UNITED STATES PATENT AND TRADEMARK OFFICE

APPLICATION NO.	FILING DATE	FIRST NAMED INVENTOR	ATTORNEY DOCKET NO.	CONFIRMATION NO.
10/823,408	04/13/2004	Susumu Moriya	0388-043850	3243

Office Action Summary

DETAILED ACTION

図 5

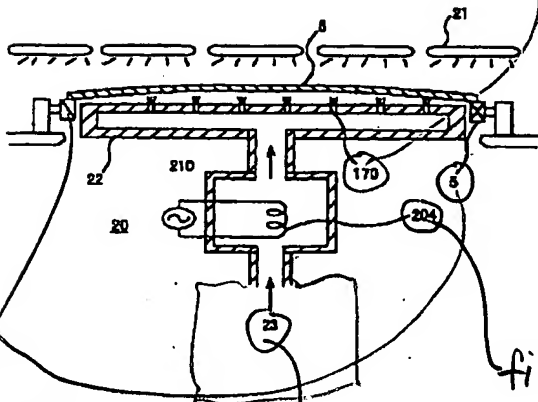
Nagate et al. Teach the claimed invention as shown on the attached marked up drawing sheets 7 and 8. Nagate et al. Fail to teach the specifics of the location of his fan/air supply. Nagate et al does show an air supply at 23 in figure 5. It would have been obvious to one of ordinary skill in the art at the time the invention was made to enclose the air supply within the same housing as the filter for the purpose of making the unit more portable and requiring less

drive rotor

air supply support means

図 6

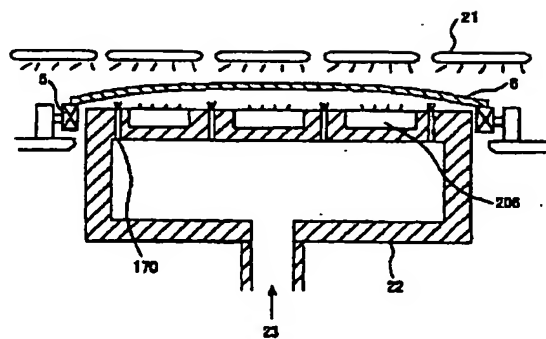
air supply means may be in same unit

【図10】

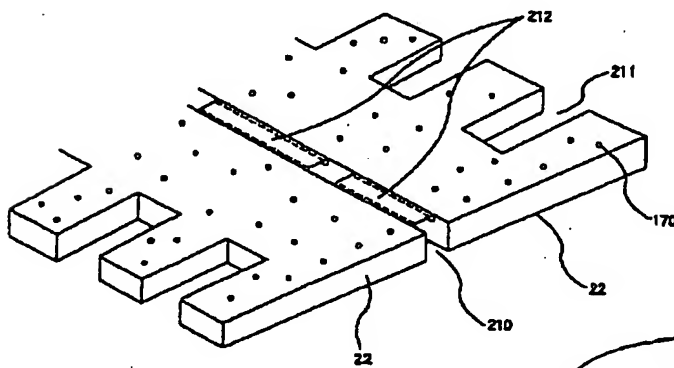
plurality of
units side by side
